ADDENDUM NO. 3

Williams Brice Stadium Plaza Site Upgrades – Construction

State Project No. H27-6104-MJ-B

2 TYP. ROOF DETAIL - ROOF EDGE
 A110 6" = 1'-0"

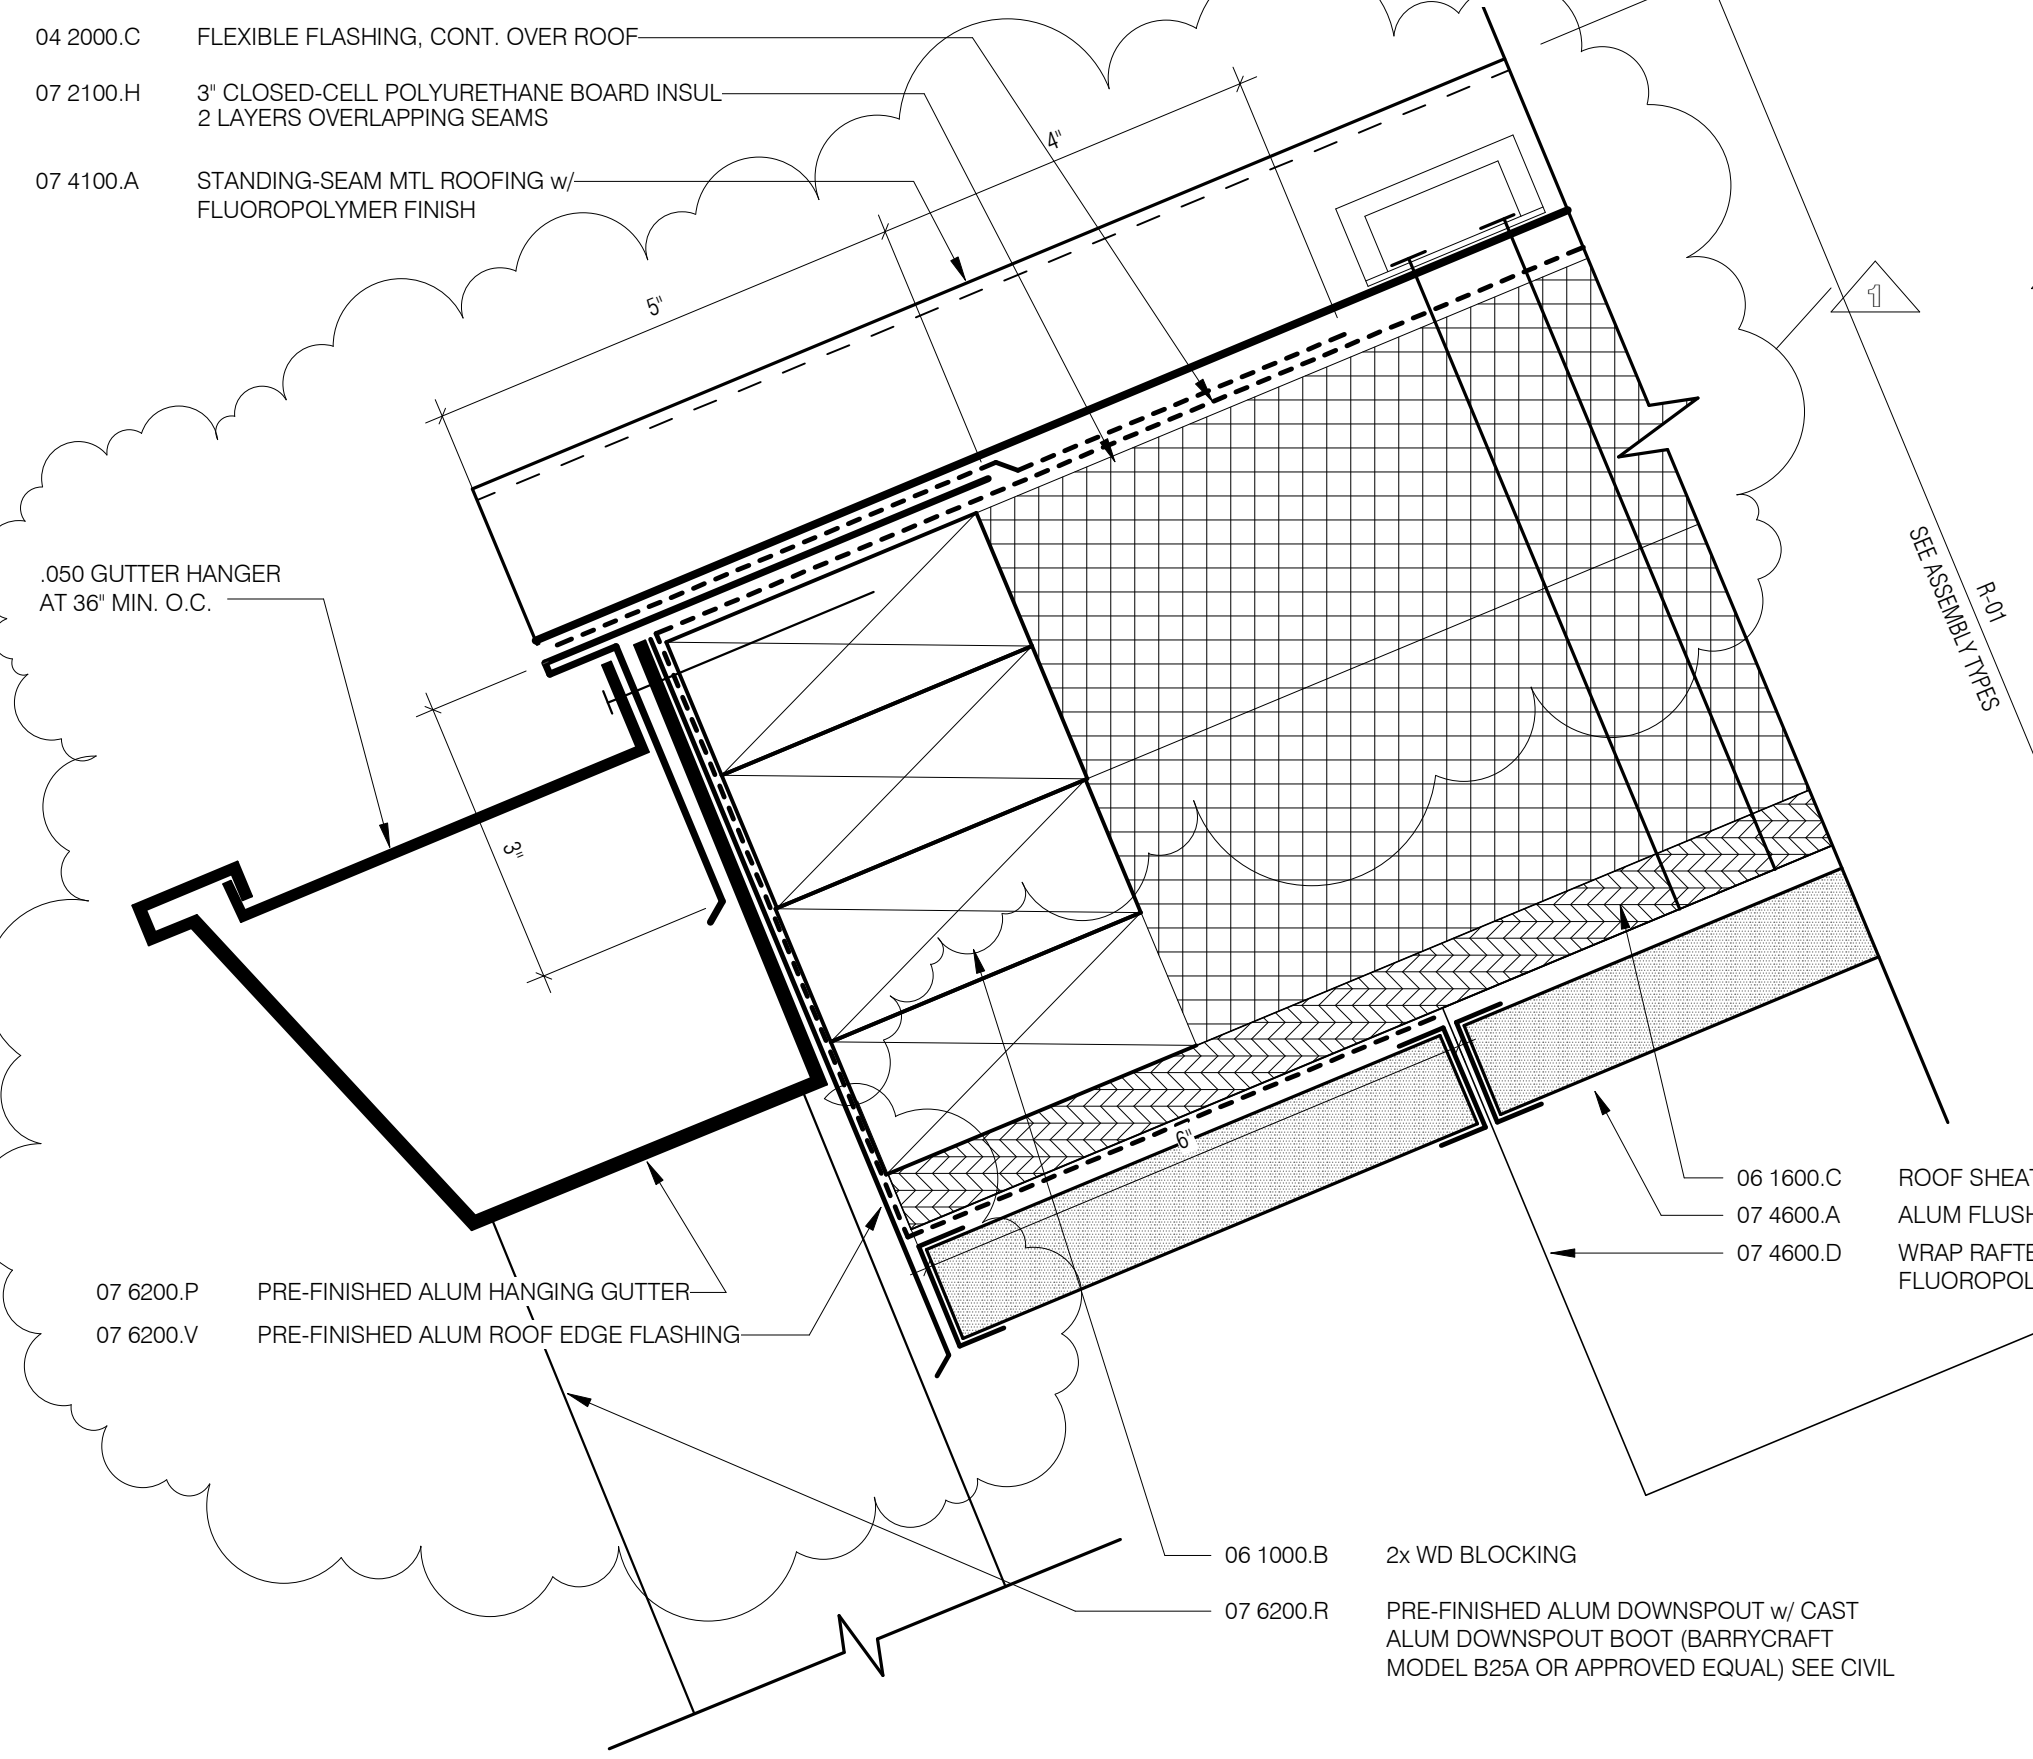
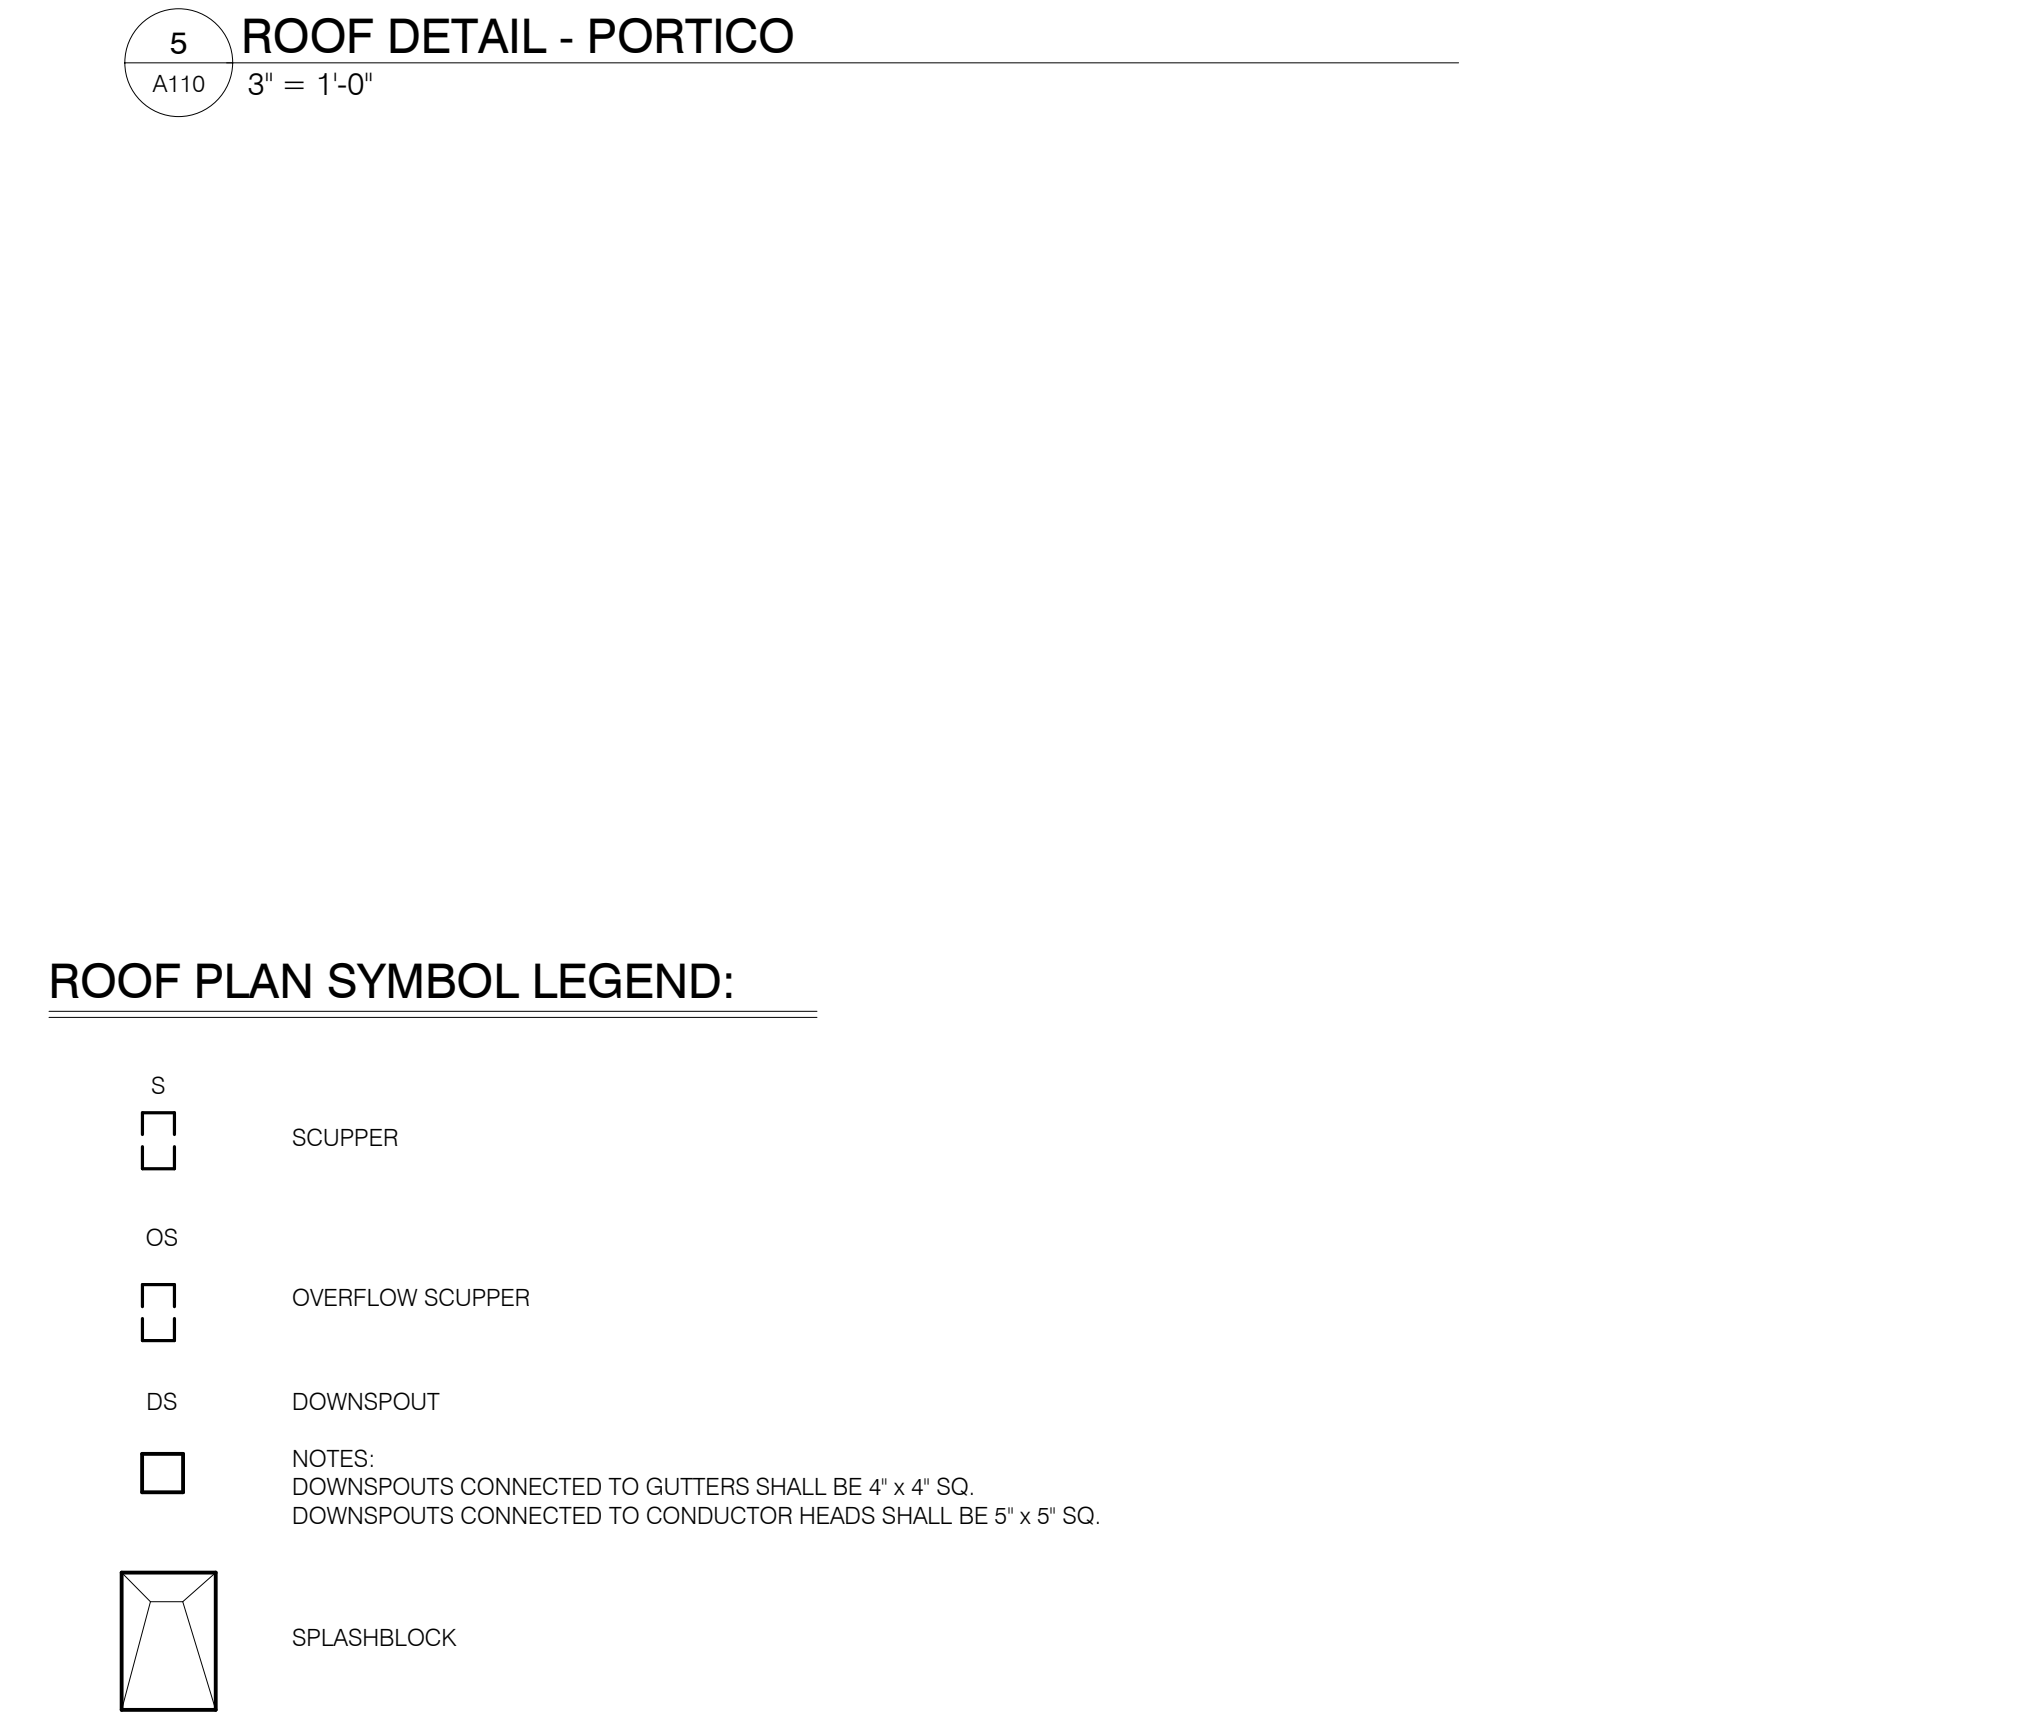
2. Drawing **“Roof Plan & Details” A110**, modify the typical roof details for the new R-value per the attached revised drawings.
3. Drawing **“FRP & Cast Stone Details” A161**, modify the FRP profiles per the attached revised drawings.
4. Contractors shall use plan sheet L200 and the legend contained therein for information pertaining to all concrete pavement locations and thicknesses. The Civil details and plans cover the asphalt pavements in the parking areas located just east of the Gameday building and on the south side of Key Road.
